First Revision No. 5258-NFPA 72-2022 [New Section after 3.3.37.2]

Figure 17.7.7.3.3.2 High Air Movement Areas (Not to Be Used for Under-Floor or Above-Ceiling Spaces).

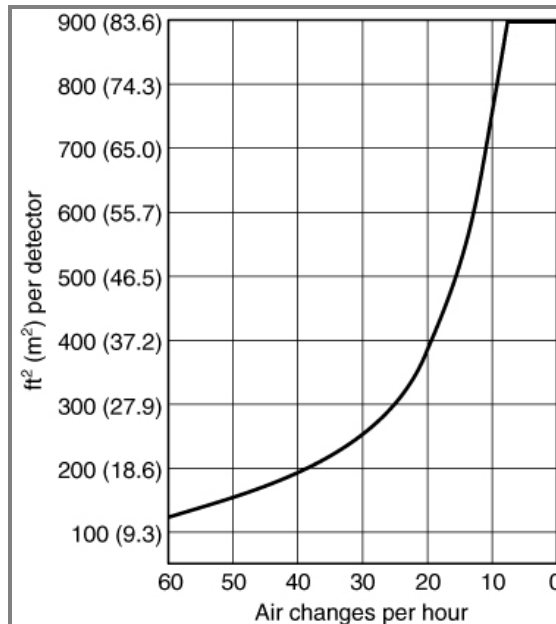
Where spacing must be adjusted for airflow, spot-type smoke detector spacing shall be adjusted in accordance with Table 17.7.7.3.3.2 or Figure 17.7.7.3.3.2 before making any other spacing adjustments required by this Code.

Committee Statement: The first revision adds language to align the table title with the type of detector covered by the requirement.
Response Message: FR-5316-NFPA 72-2022

Figure A.17.6.3.1.1(e) Typical Rectangles for Detector Curves of 15 ft to 50 ft.

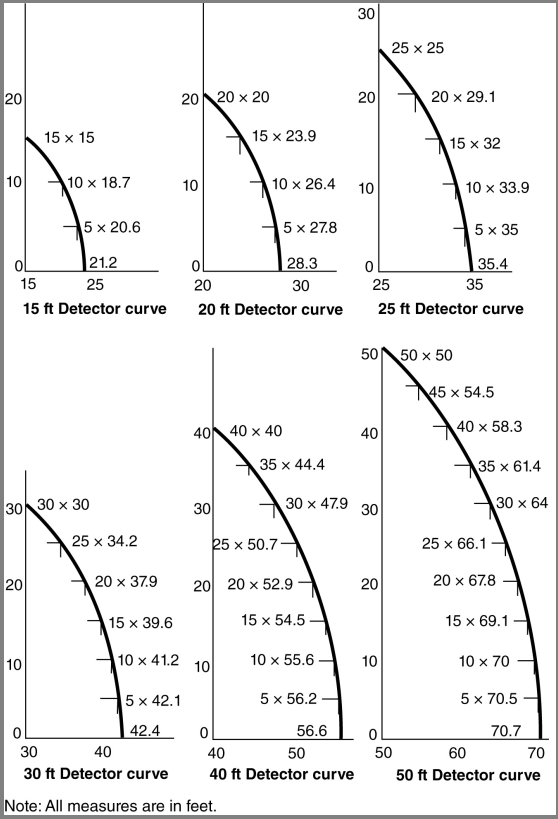
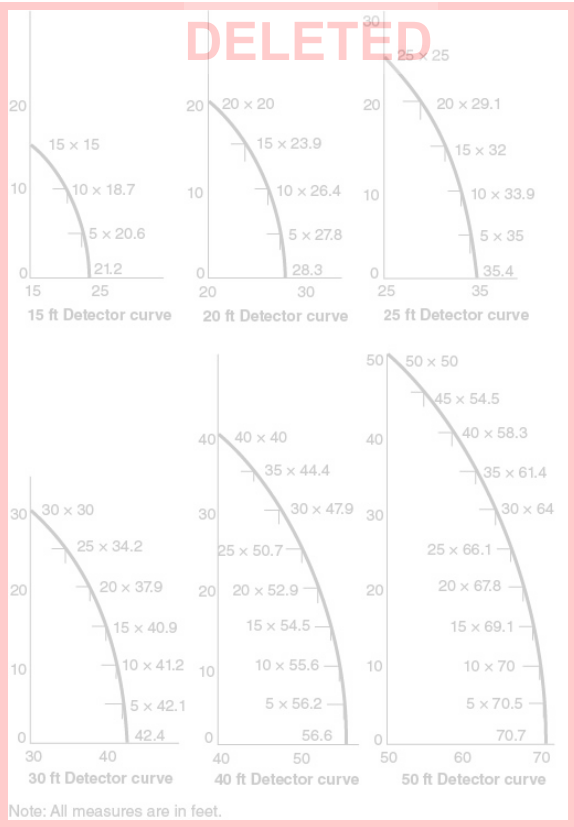
Committee Statement: Revised 30 ft Detector curve with updated spacing for 15 ft dimension matching Figure A.17.6.3.1.1(g) letter B Rectangle and following the "0.7 times" rule.
Response Message: FR-5285-NFPA 72-2022

Figure A.17.7.1.11 Smoke Detector Layout Accounting for Stratification.

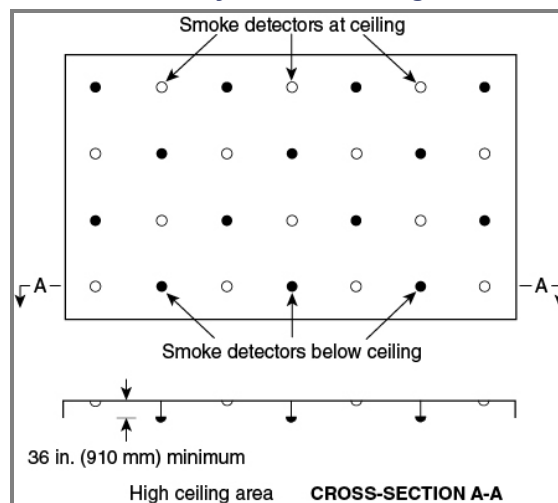
In installations where detection of smoldering or small fires is desired and where the possibility of stratification exists, ~~consideration should be given to~~ mounting a portion of the detectors below the ceiling should be considered. In high-ceiling areas, projected beam-type or air sampling-type detectors at different levels also should be considered. (See Figure A.17.7.1.11.) Video image smoke detectors can overcome the effects of stratification when they are capable of detecting any smoke within their field of view. That is, the smoke does not need to rise to the level of the detector for effective sensing.
